North Anna Unit 3 COLA

Seismic Closure Plan
COLA Markup/RAI Revision
Submission February 23, 2015

April 1st, 2015

V/H: Implementation of NUREG/CR-6728

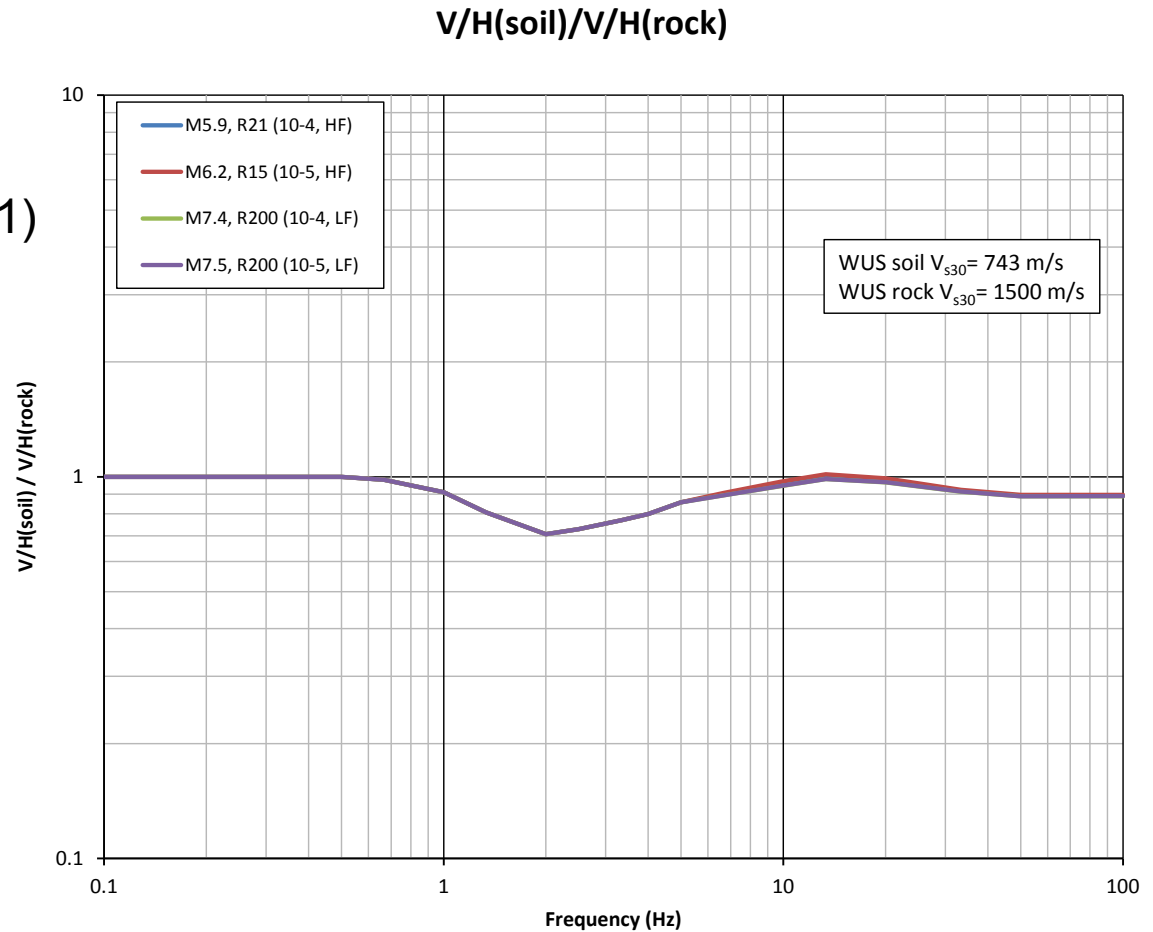
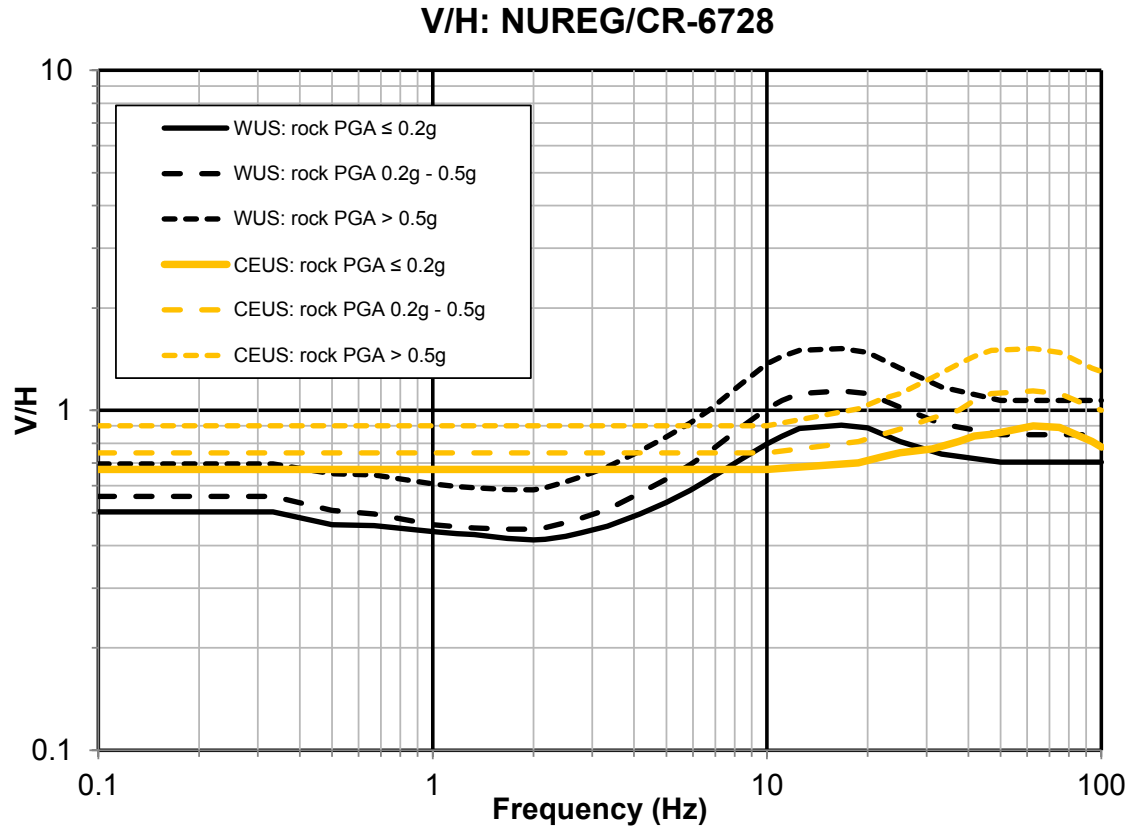
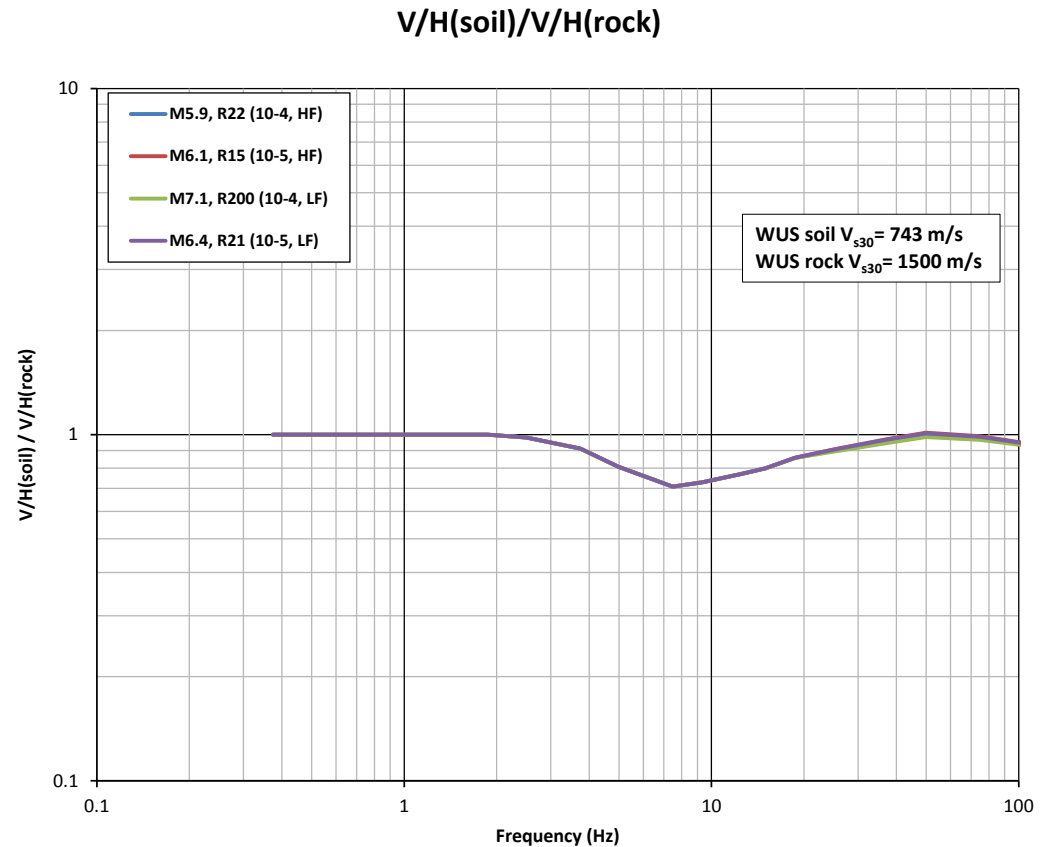
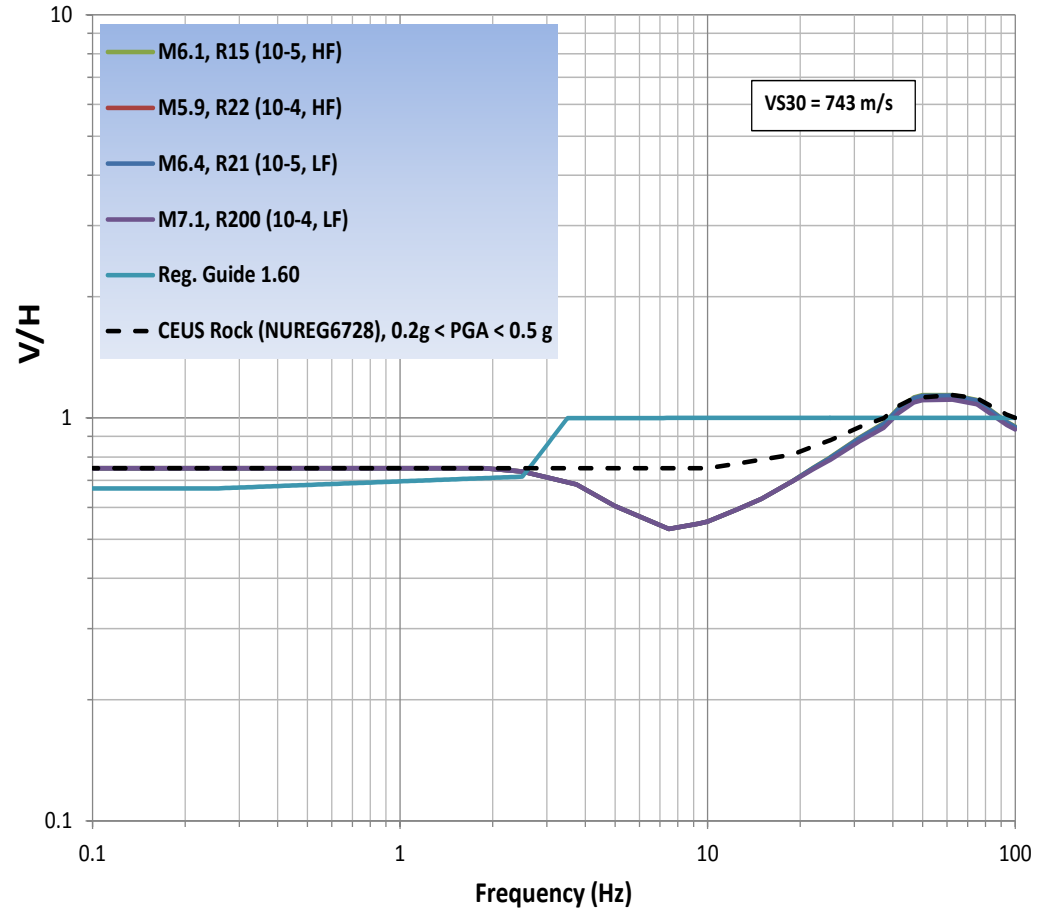
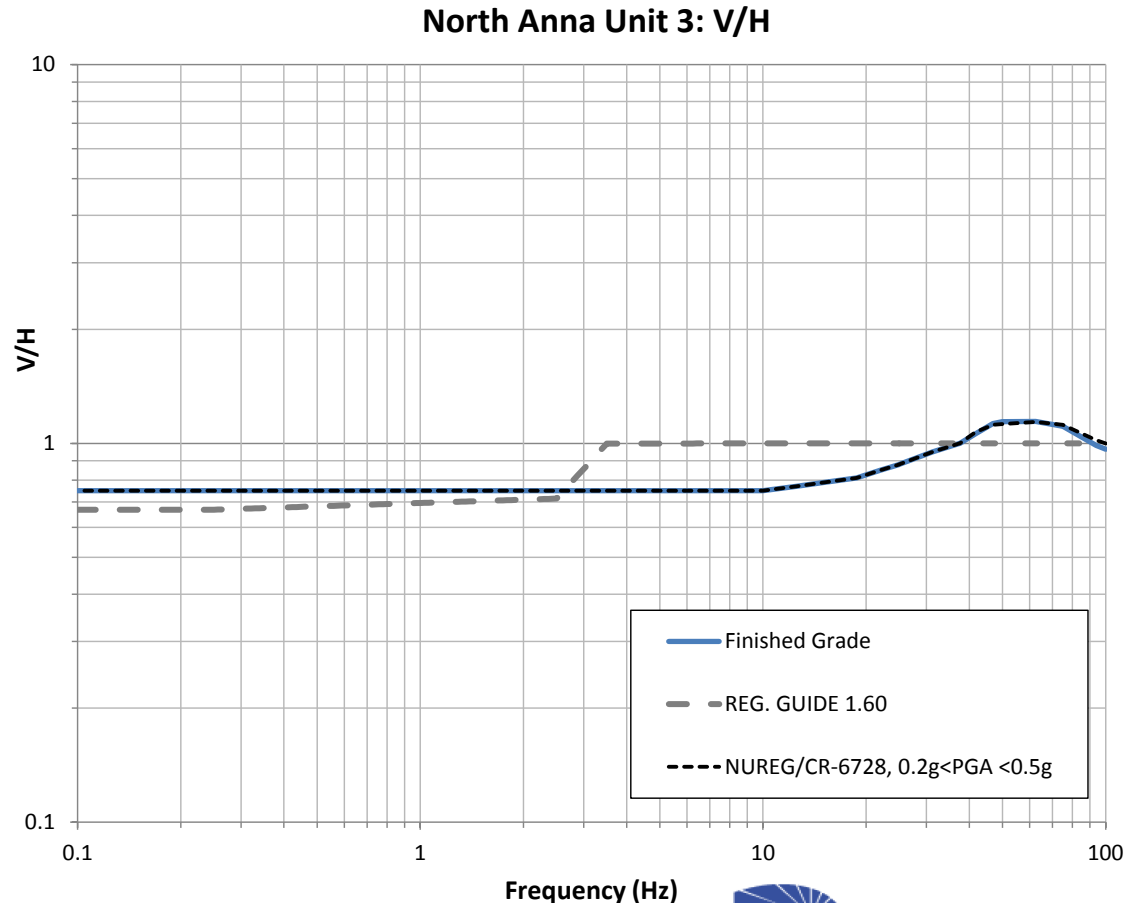
NRC Meeting Question #1

Topic: Development of vertical FIRS and PBSRS for RB/FB, CB and FWSC from horizontal FIRS and PBSRS.

The following equation indicates an implementation of the NUREG procedure used in the FSAR:

Analogous to the first-order transformation from WUS to CEUS used in the NUREG for rock, perform a frequency shift of (62.5/16.7) to transform f (rock-to-soil)_{WUS} to CEUS f (rock-to-soil)_{CEUS}

The dip [low values] in the V/H ratios in the frequencies between about 2 and 20 Hz may be considered, by some, to be an unconservative or WUS-biased character, so the CEUS rock V/H is used as a “floor” to prevent the dip.

Note: The NUREG procedure is not explicitly prescriptive, as evidenced in the various ways in which it has been used in various ESPs and COLAs.

The beneficial aspect of the procedure used here is that as V_{S30} approaches the higher rock values, the ratio $V/H_{\text{WUS,soil}} / V/H_{\text{WUS,rock}}$ goes to 1.0 at all frequencies, giving the $V/H_{\text{CEUS,rock}}$ as given in the NUREG.
